Conversion of Nether Mill Barn, Penistone S36 8AD
To form Veterinary Surgery on Behalf of Donaldson's Vets Ltd

Our Ref: C1096 453; Statement to Accompany an Application to Vary Planning Condition 2 (Planning Application Ref: 2022/0744)

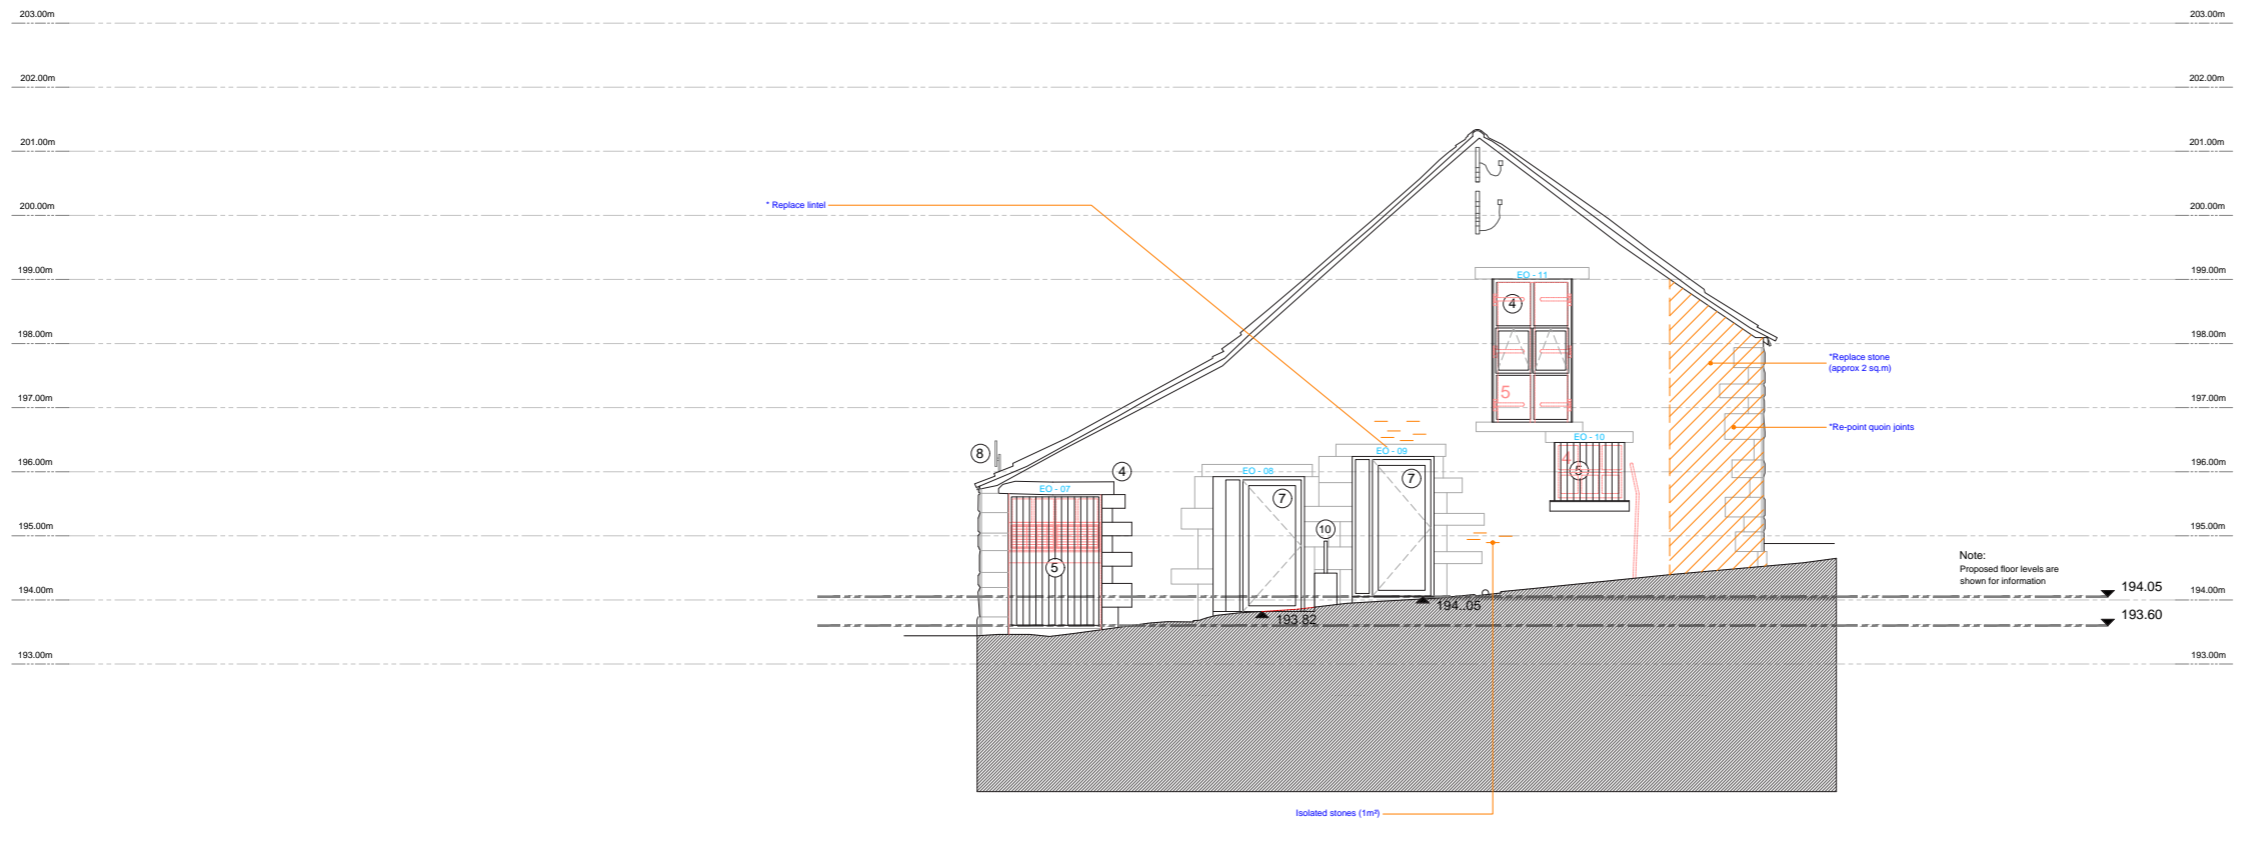
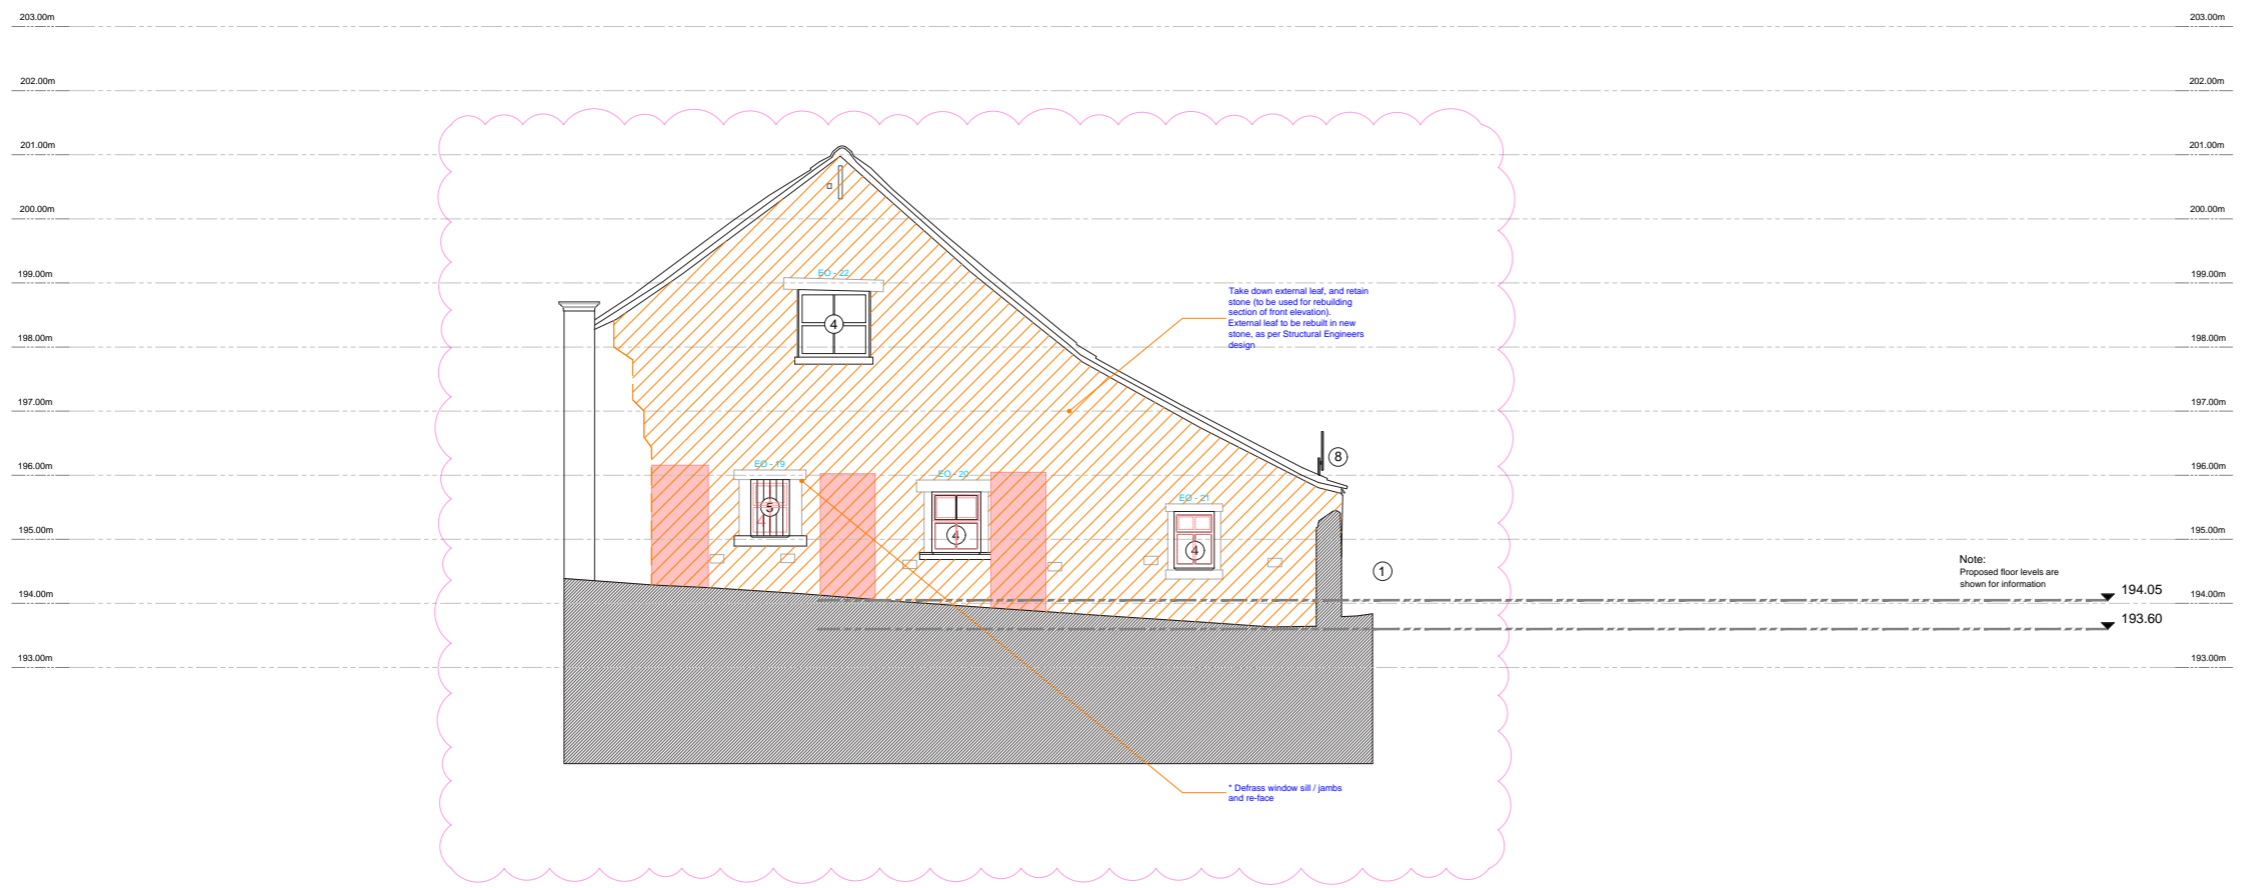
- Rev 8 2024.03.10 Brickwork buttressing removed as per demolition scope updates. Proposed works to existing stone updated
 - Rev 7 2024.02.27 Stonework repair / replace annotations added, as per Gate & Bar Ltd comments

- Drawing Notes:**
- 2a Existing stone walling to be taken down (see Dawson Williamson Ltd drawing ref: C1096_050_051_052,053), retained on site, dressed for re-use and re-built in the recessed panels to the arrangement shown (2c)

- 2b New triple glazed aluminium framed glazed panels with projecting sill (fixed)
 - 2c Existing stonework to be used to form lower (recessed) panels with 25mm set back from the face of the adjacent stonework

Sheet Size: A1 | Drawing No: 21642-DR-S-0300 | Revision: C4

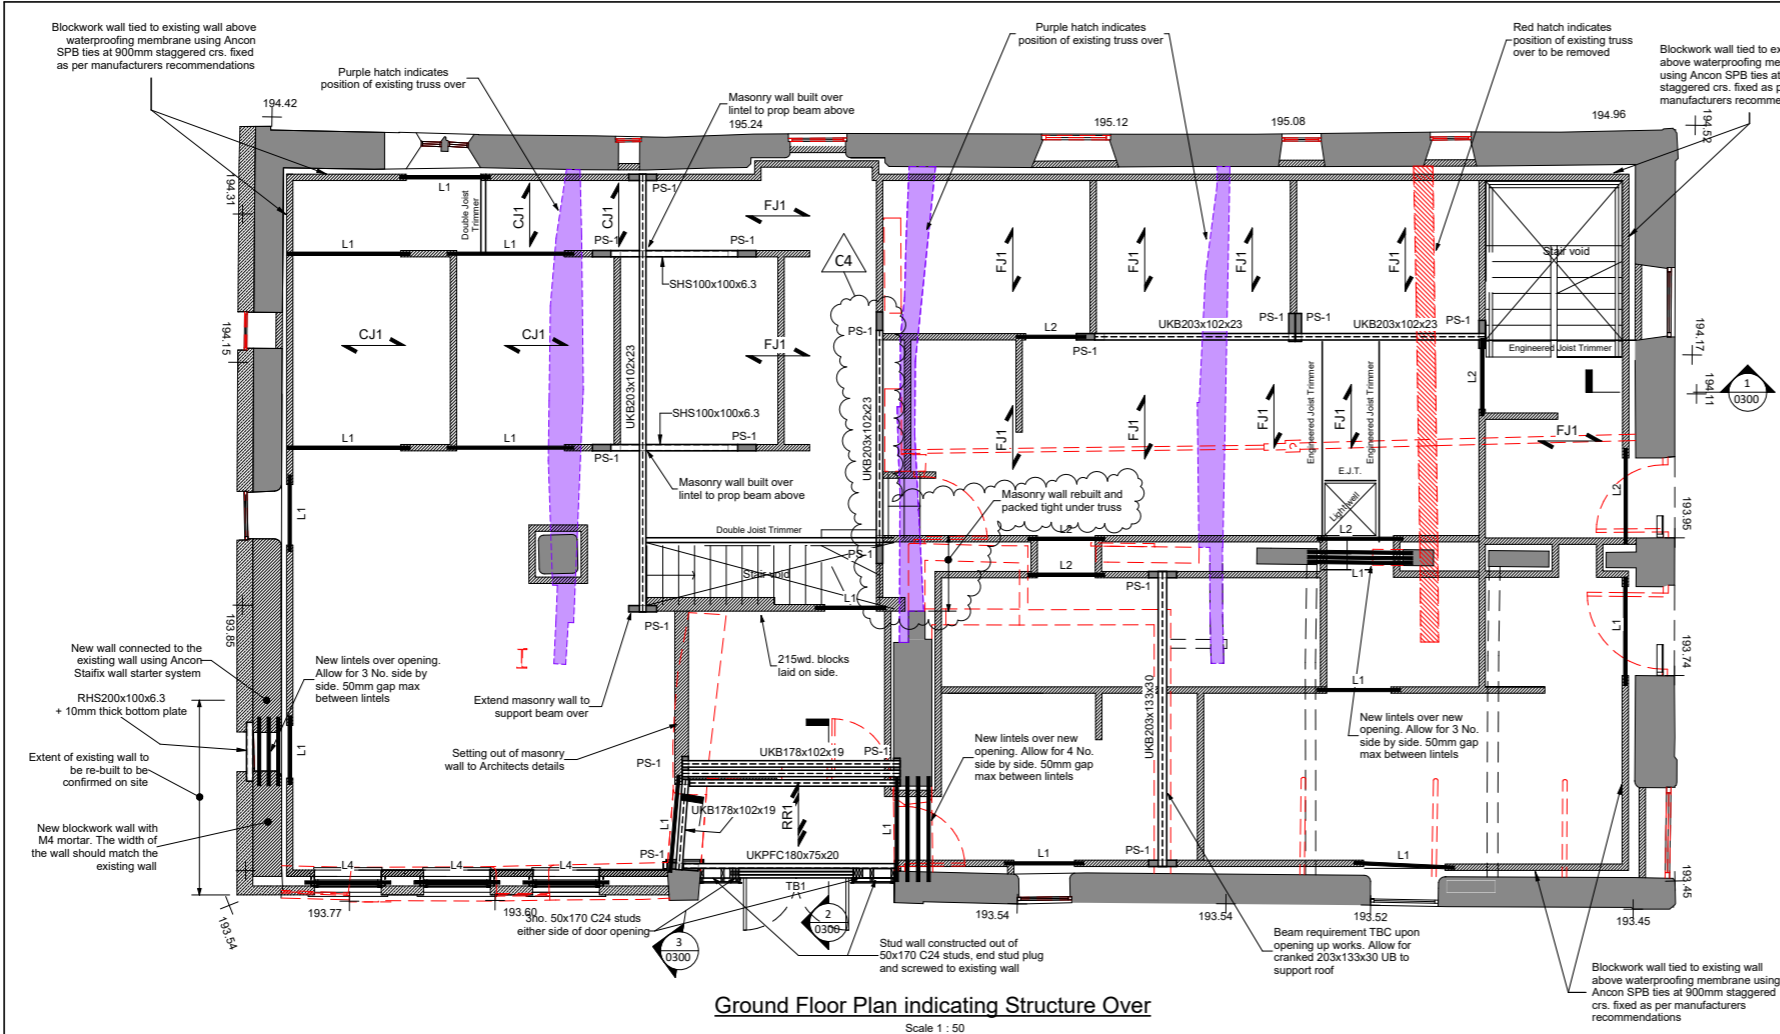
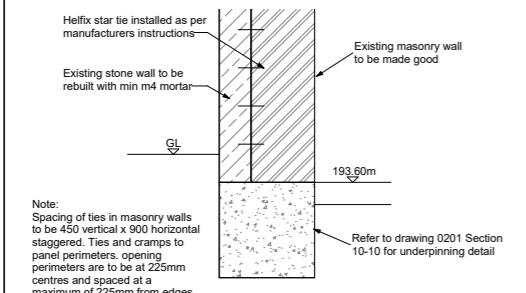
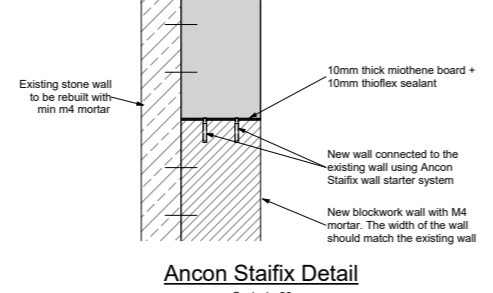
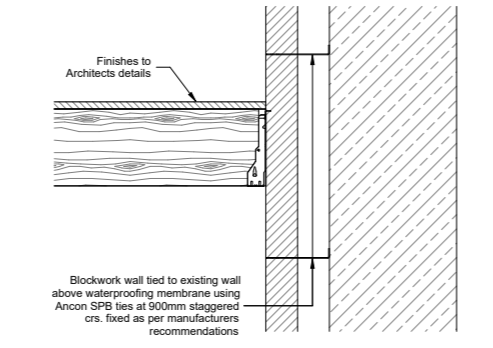
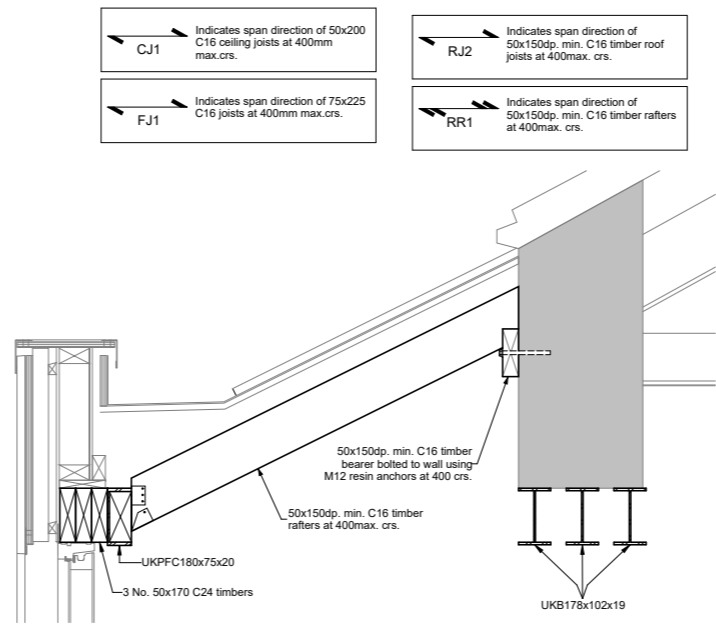
No.	Revision	Date	Chk	Drwn
P1	Approval issue	31.08.23	ABa	GH
P2	Amended to suit Site visit	07.07.23	ABa	GH
P3	Front elevation and entrance amended to suit Architects drawings	21.08.23	ABa	GH
P4	Updated to suit latest Architects drawings	31.08.23	ABa	GH
PS	Ceiling joists added	10.10.23	ABa	GH
C2	Existing pier rebuilt. Proposed structure amended to suit	05.02.24	ABa	GH
C3	Upstand omitted, slab reinforcement amended. Gable wall repair details added. Sections 2, 11 & 12 amended. Section 15-13 added.	23.02.24	ABa	GH
C4	Steelbeam added to support floor joists where existing wall is demolished. Pier rebuilt under existing truss.	14.03.24	ABa	GH

3.3.1 The project Structural Engineer (Topping Engineers Ltd) have prepared a number of technical drawings and details in response to the issues which have been raised on site. These drawings are included on the following pages for reference.
